**MEETING OF THE
PLANNING AND ZONING BOARD
QUASI-JUDICIAL PUBLIC HEARING**

February 16, 2016

Subject: Site Development Plan Application
AKUA – 30 DU Multi-family Residential Complex
9740-60 W. Bay Harbor Drive
Bay Harbor Islands Acct. No. BP2015-449
MMPA Acct. No. 01-0702-1030

From: Scott D. Marks *SDM*
Community Planner
MMPA-Consultant Town Planner

SITE PLAN - LEVEL 1 FLOOR PLAN

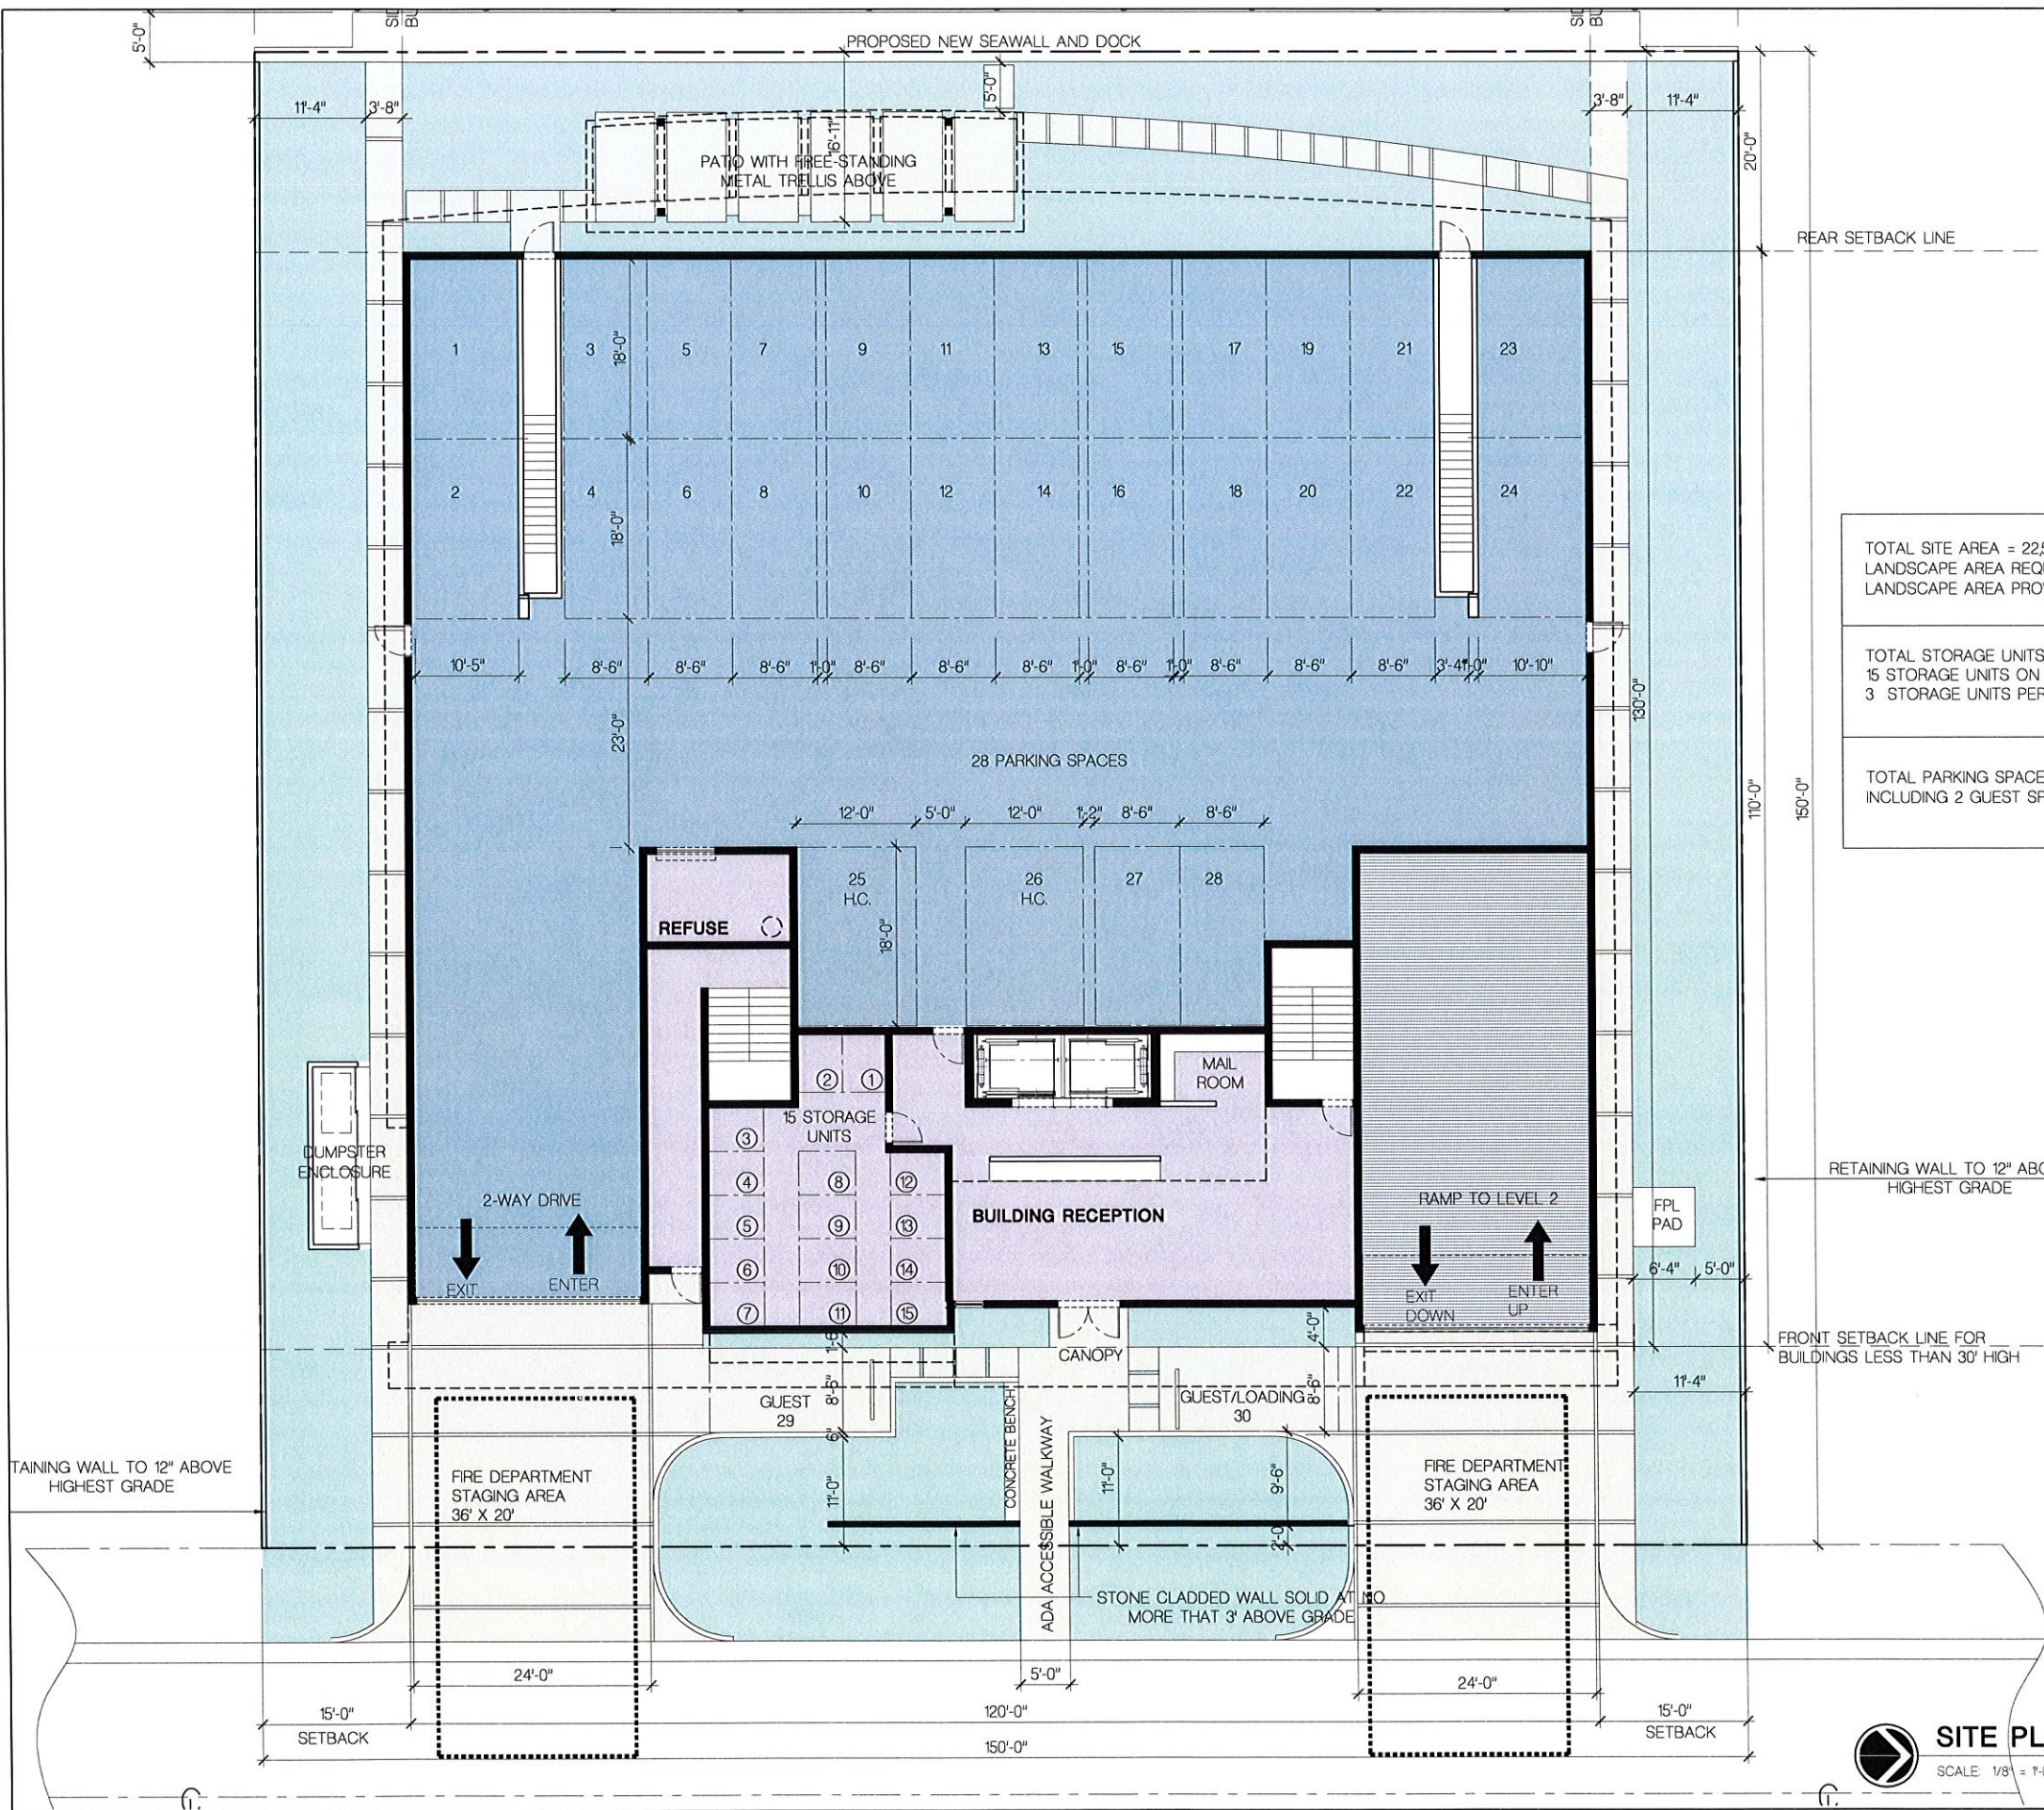
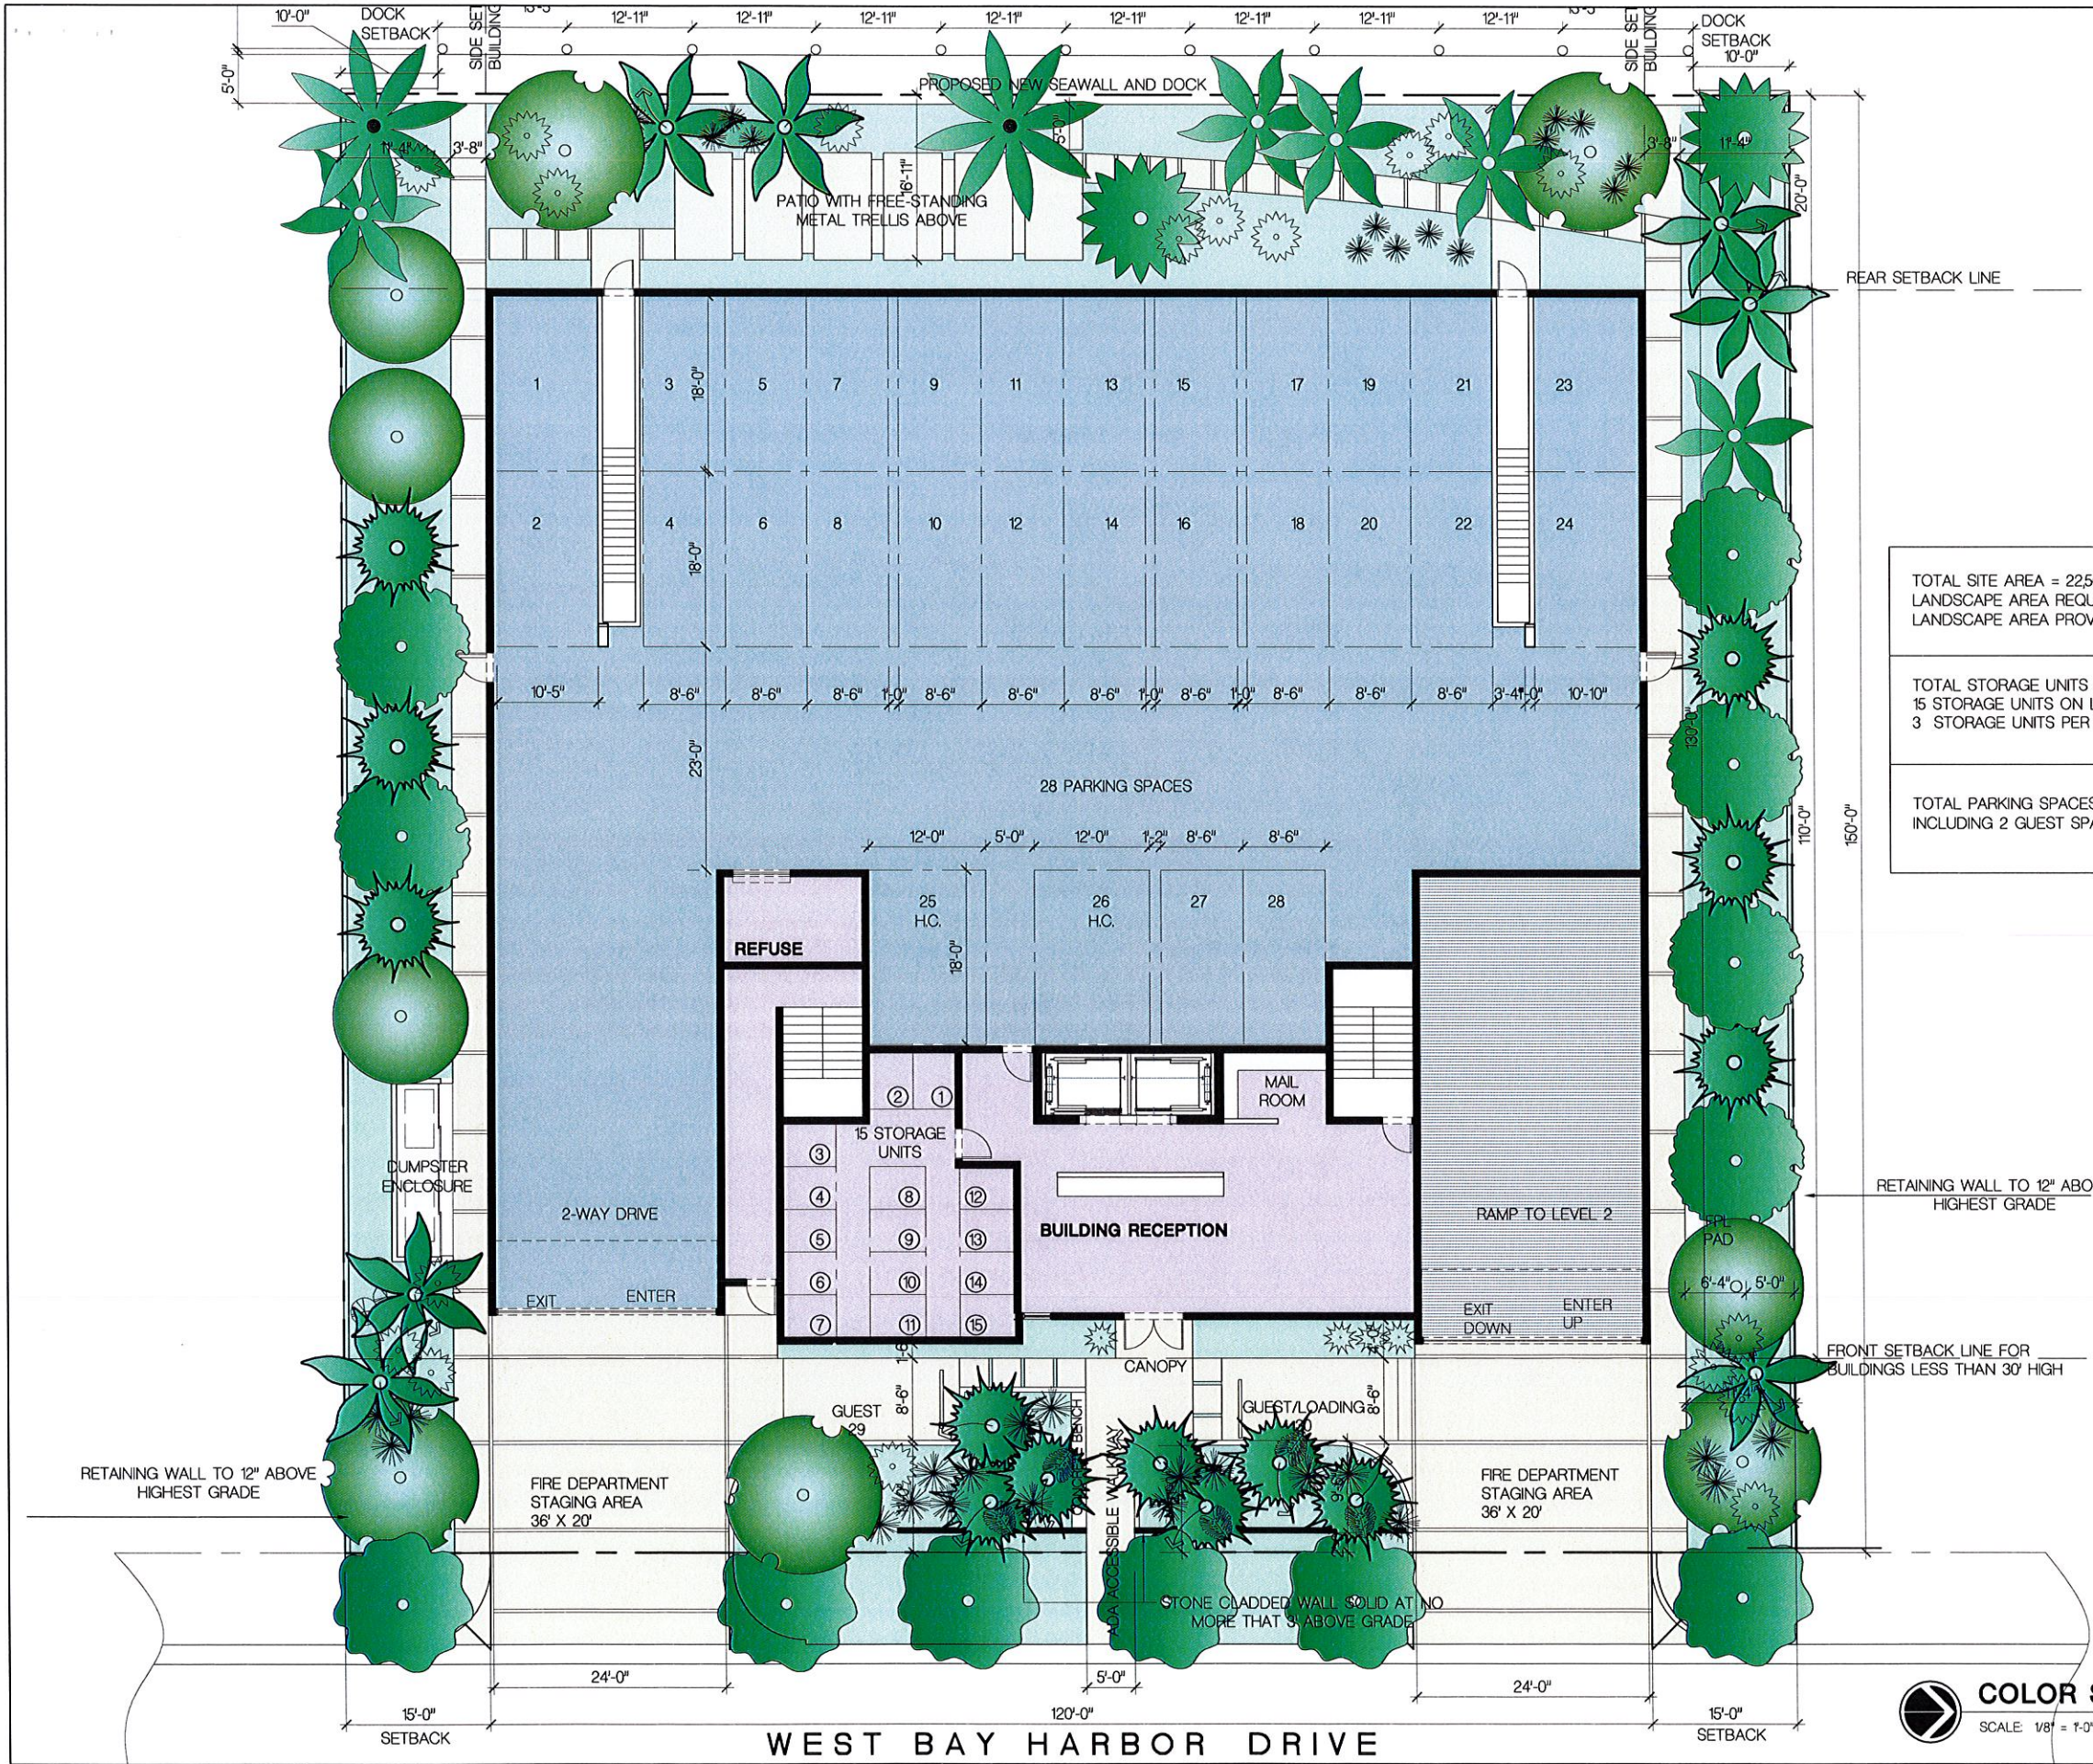
As stated above, the Site Development Plan depicts access to the site from two (2) 24-foot wide two-way driveway connections to W. Bay Harbor Drive. The southern driveway provides access to one (1) guest parking space in the front yard area as well as the lower level of the parking garage. The northern driveway also provides access to one (1) guest parking space in the front yard area as well

as the second level of the parking garage. Based on 30 DU the Code requires at least sixty (60) parking spaces. Sixty-two (62) parking spaces are provided (48 tandem, 10 standard and 4 ADA spaces). As this is a two-lot development, two (2) guest spaces are required as well as a drop-off area near the lobby entrance which the plans meet.

Two Fire Department staging area are shown on the plans; one in the apron of each driveway. Any changes required by the Fire Department subsequent to the Town's site plan approval may cause the plans to be re-submitted to the DRC / PZB.

FIRST FL. PLAN
SCALE: 1/4"=1'-0"

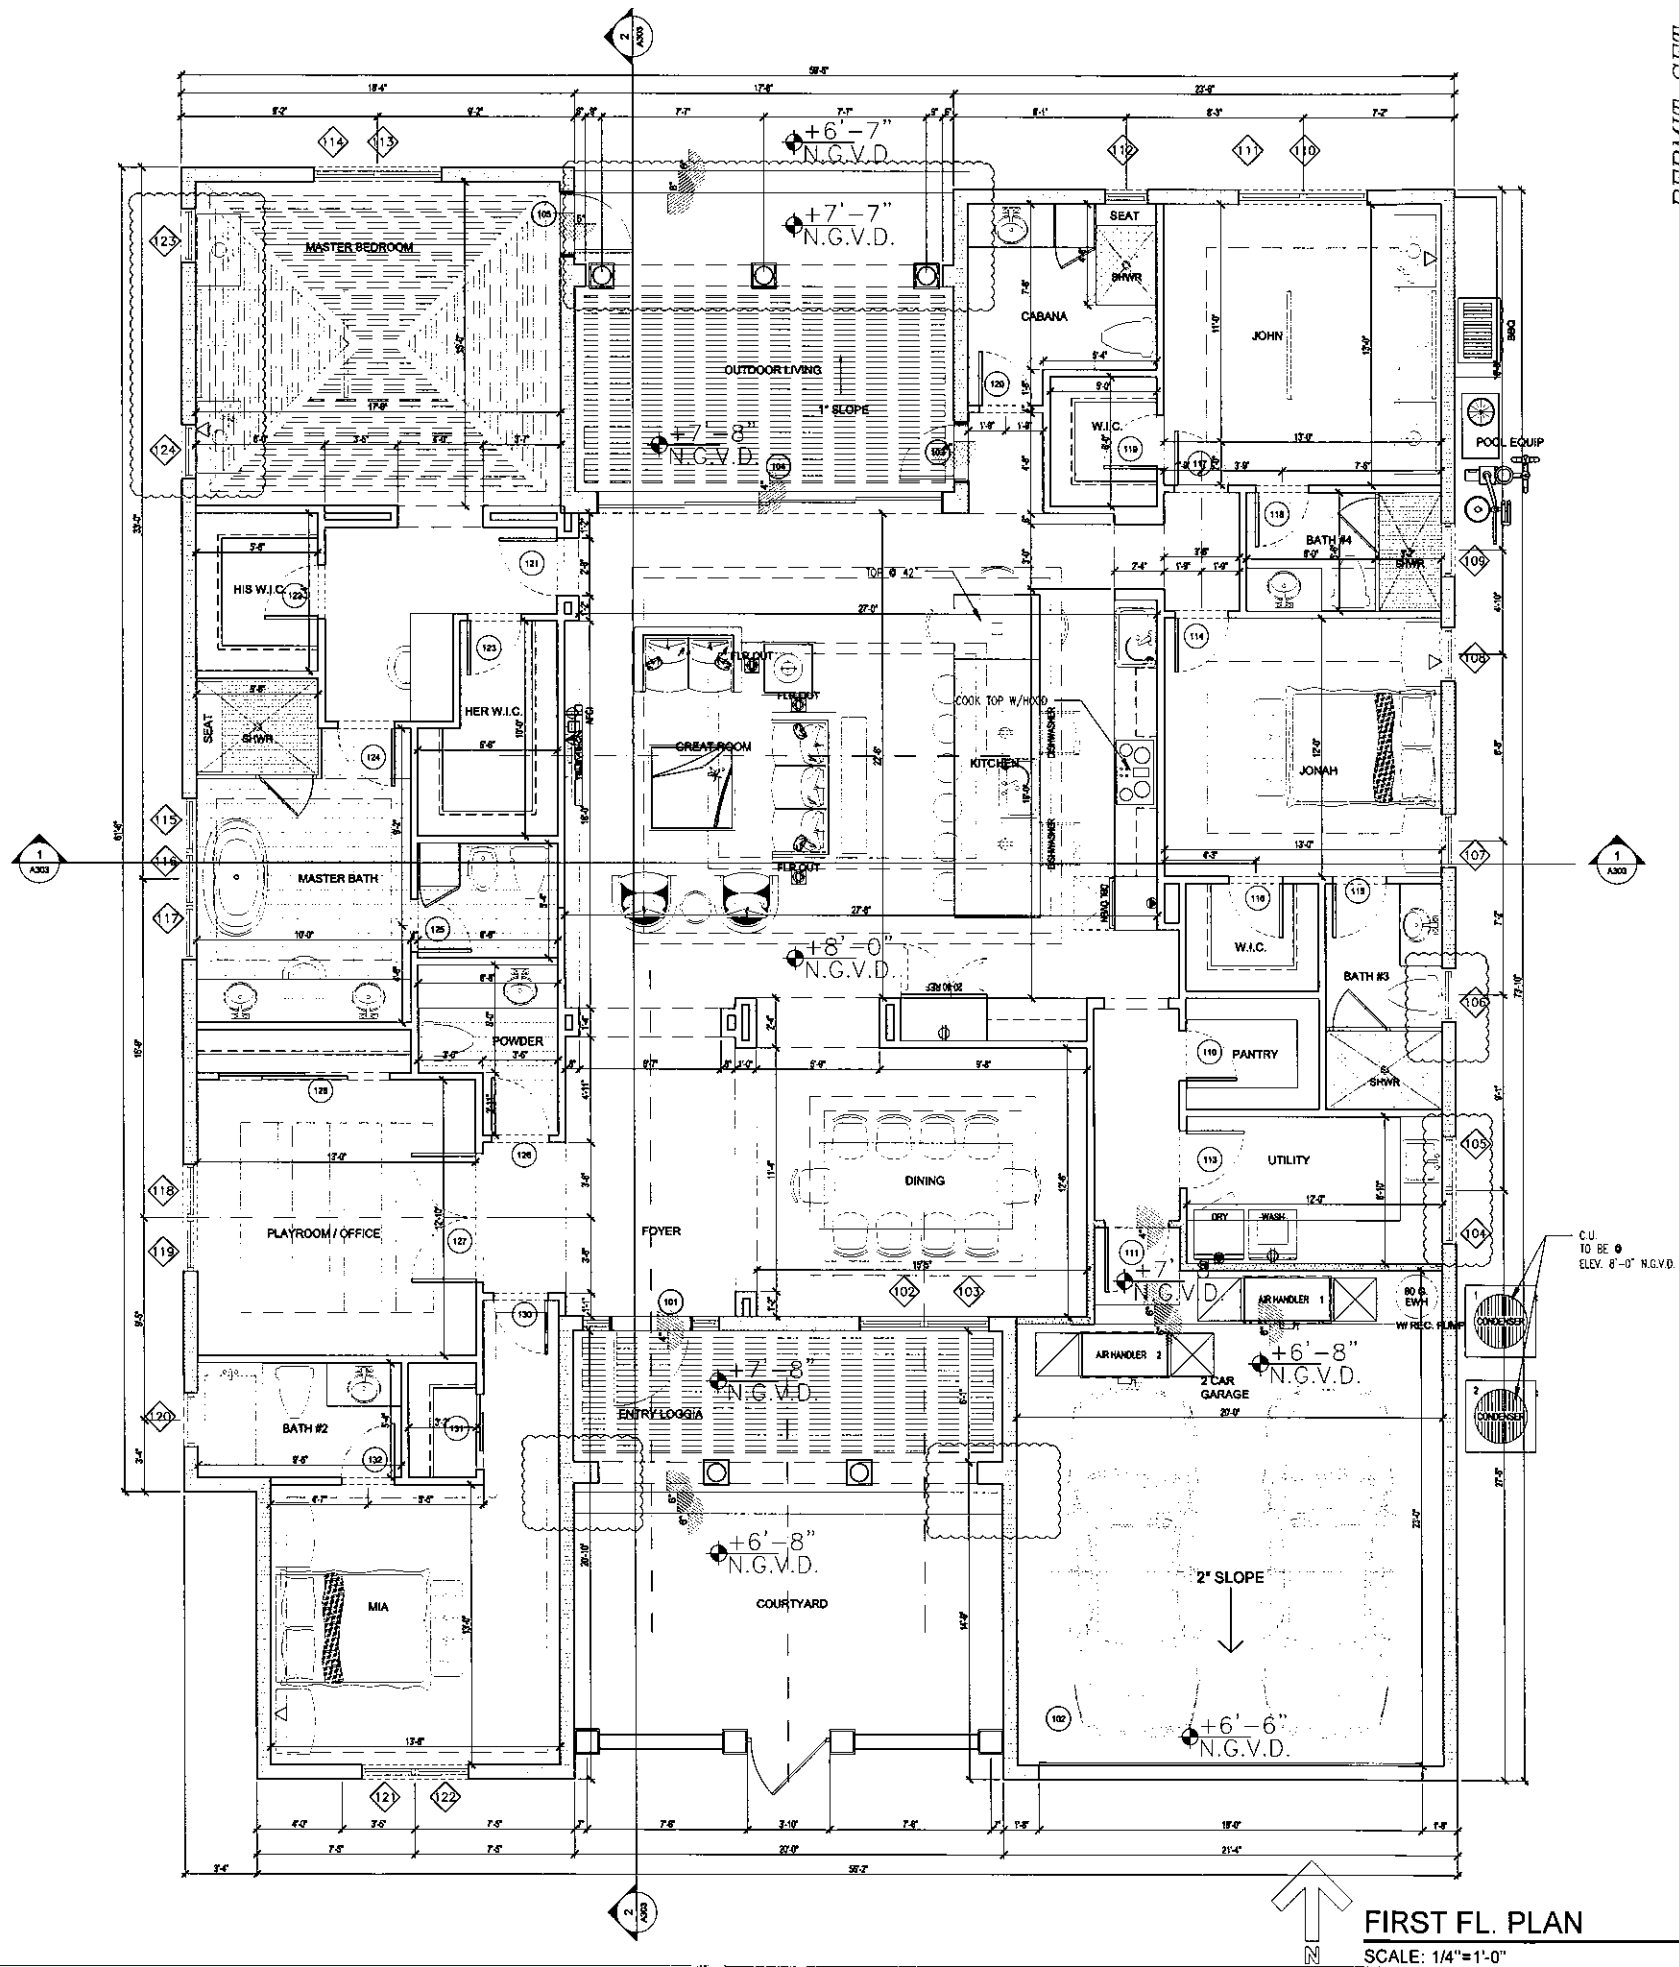
MMPA notes that the PZB requested a door be placed in the garage / utility room to provide access to the garbage cans in the side yard. The applicant has indicated that the owner does not want any doors in that location for security reasons. MMPA also informed the applicant that the landscaping on the renderings does not match the landscape plans; the applicant indicated that the landscaping shown on the renderings is for presentation purposes only and that the landscape elevations show the proposed landscape material accurately.
